**IMPERVIOUS MEMBRANE SWALE LINING TO FURNACE BROOK**

<b>VERMONT AGENCY OF TRANSPORTATION</b>	
	PROJECT NAME: BENNINGTON
	PROJECT NUMBER: AC NH 019-1(51)
DESIGN SUPERVISOR: GREG EDWARDS	DRAWN BY: STANTEC
DESIGNED BY: MARC FOISY	CHECKED BY: GARY SANTY
<b>STORMWATER MANAGEMENT SWM-05</b>	SHEET 89 OF 367

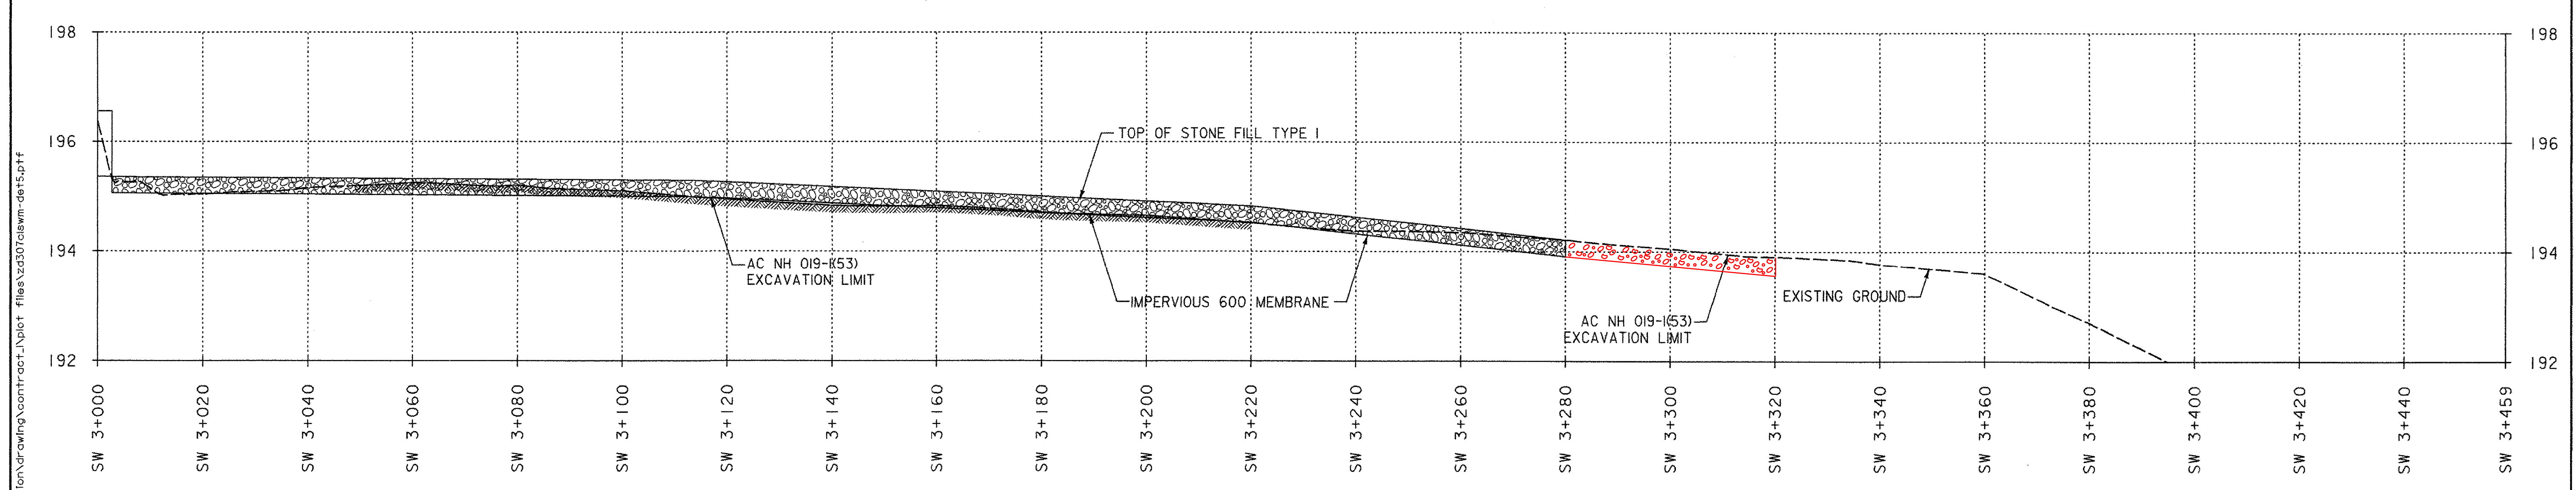
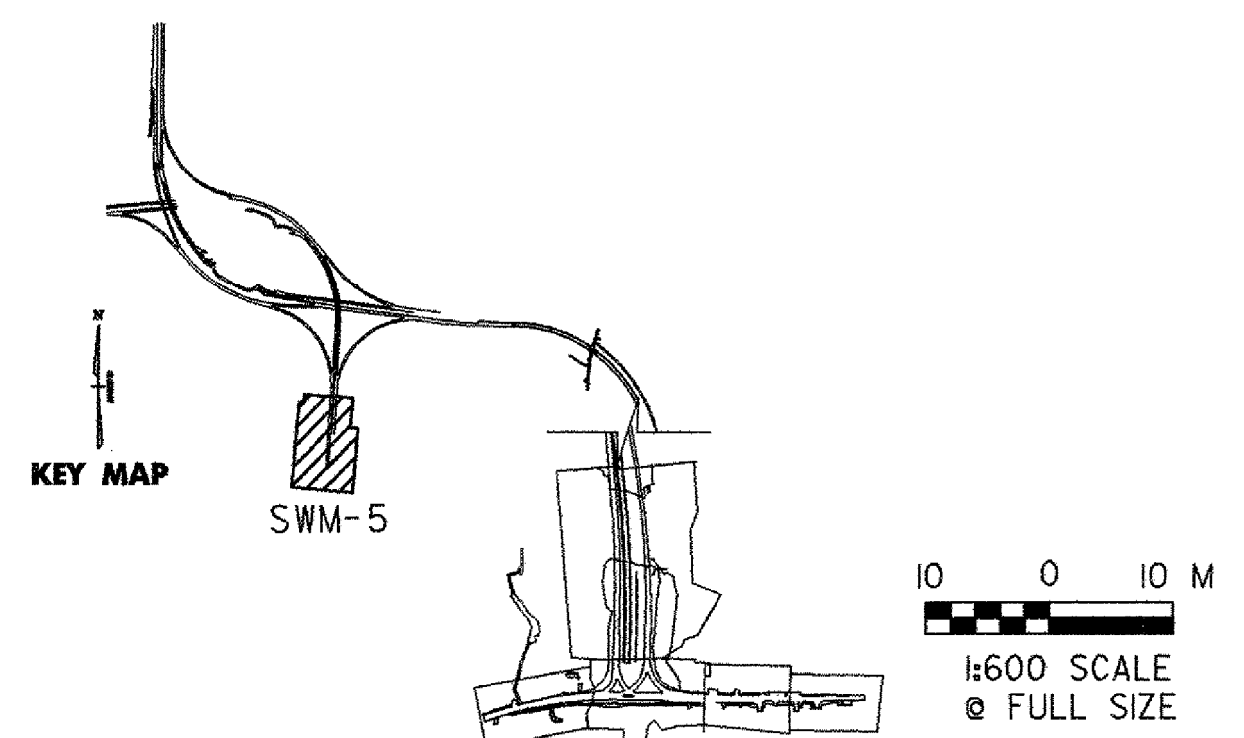
NOTE:  
1. GEOMEMBRANE SHALL BE IMPERVIOUS, CONSIST OF A MINIMUM 60 MIL HIGH DENSITY POLYETHYLENE LINER, AND CONFORM TO VAOT MINIMUM AVERAGE ROLL VALUES OF GRAB TENSILE STRENGTH, BURST STRENGTH, PUNCTURE, TRAPEZOIDAL TEAR STRENGTH AND UV RESISTANCE FOR STD. SPECIFICATION 649, & TABLE 720.04A. INSTALLATION OF GEOMEMBRANE SHALL BE PER MANUFACTURER'S INSTALLATION INSTRUCTIONS. GEOMEMBRANE TO BE PAID ~~AS INCIDENTAL TO STONE FILL TYPE I~~ UNDER ITEM CODE 900.575 60 MIL HDPE LINER.
